SUBJECT: SURRY POWER STATION, UNIT 1 - AMERICAN SOCIETY OF MECHANICAL ENGINEERS BOILER AND PRESSURE VESSEL CODE, SECTION XI, RELIEF REQUEST PRT-01 (TAC NO. MC1830)

SAFETY EVALUATION BY THE OFFICE OF NUCLEAR REACTOR REGULATION

RELIEF REQUEST PRT-01

SURRY POWER STATION, UNIT 1

**Figure 1** Cross-sectional view of head-to-flange weld showing the required inspection volume (within dashed lines) and UT beam. The figure illustrates that inspection from the flange side is severely limited due to transition angle and location of weld.

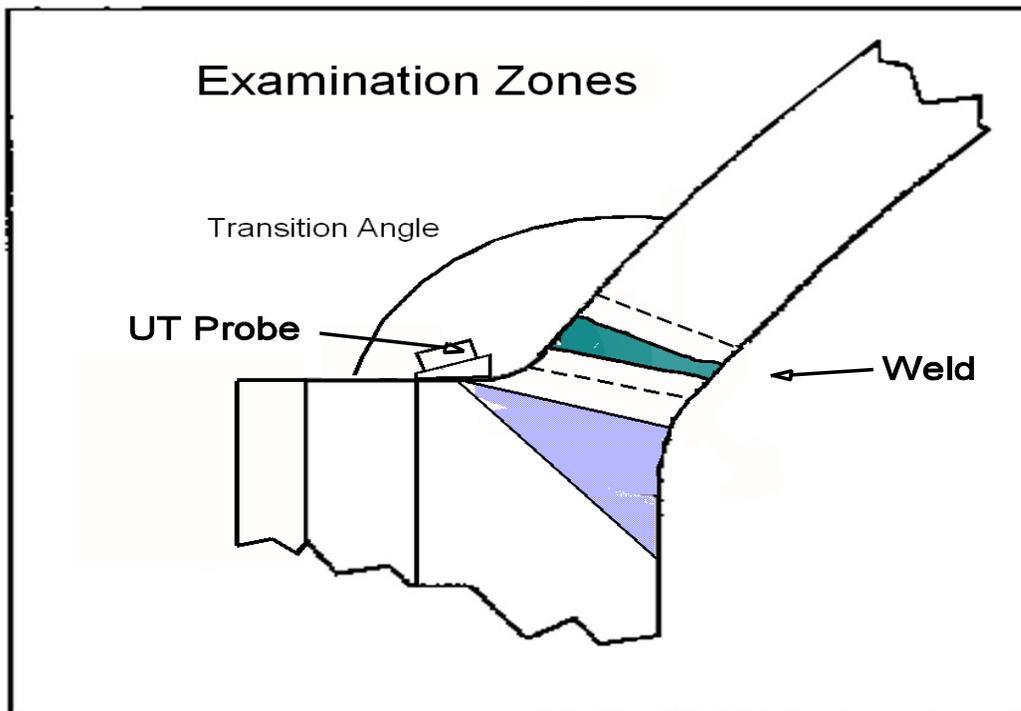
The cross-sectional geometry of the RPV head-to-flange weld produces a high transition angle between the flange and the domed head. As illustrated in Figure 1, scanning from the flange side of the weld is severely limited due to location of the weld and the transition angle. In addition, the location of three closure head lifting lugs further restricts access for performing ultrasonic examination of this weld. For these reasons, the component configuration does not allow the licensee to obtain the full ASME Code-required volumetric coverage from both sides of the weld. For the licensee to achieve 100-percent volumetric coverage, the RPV closure head would have to be redesigned and modified. This would place a significant burden on the licensee, thus the ASME Code-required 100-percent volumetric examination is impractical for the head-to-flange weld.

By letter dated January 22, 2004, the licensee provided information showing that a substantial amount (approximately 66 percent) of the ASME Code-required examination volume can be

obtained with the perpendicular, parallel and 0-degree angle ultrasonic scans that were performed from the head side of the weld. For both the 45- and 60-degree angle scans, the licensee was able to achieve the ASME Code-required coverage from a single side. In addition to the volumetric examinations of this weld, the licensee was able to obtain essentially 100 percent of the ASME Code-required surface examinations performed on the outside of the component. The examinations completed by the licensee establish a reasonable basis for comparison with future inservice examinations and should have detected any significant conditions that might challenge the structural integrity of the subject welds. Therefore, the licensee's proposed alternative provides reasonable assurance of structural integrity of the subject component.

The NRC staff concludes that for RR PRT-01, the required Code examination coverage is impractical to perform on the subject RPV head-to-flange weld. Furthermore, the NRC staff concludes that the coverage obtained from ultrasonic and surface examinations provides reasonable assurance of structural integrity of the subject component. Therefore, RR PRT-01 is granted pursuant to 10 CFR 50.55a(g)(6)(i) for the third 10-year ISI interval for SPS-1. The NRC staff notes that this approval is only applicable to the preservice examination requirements.
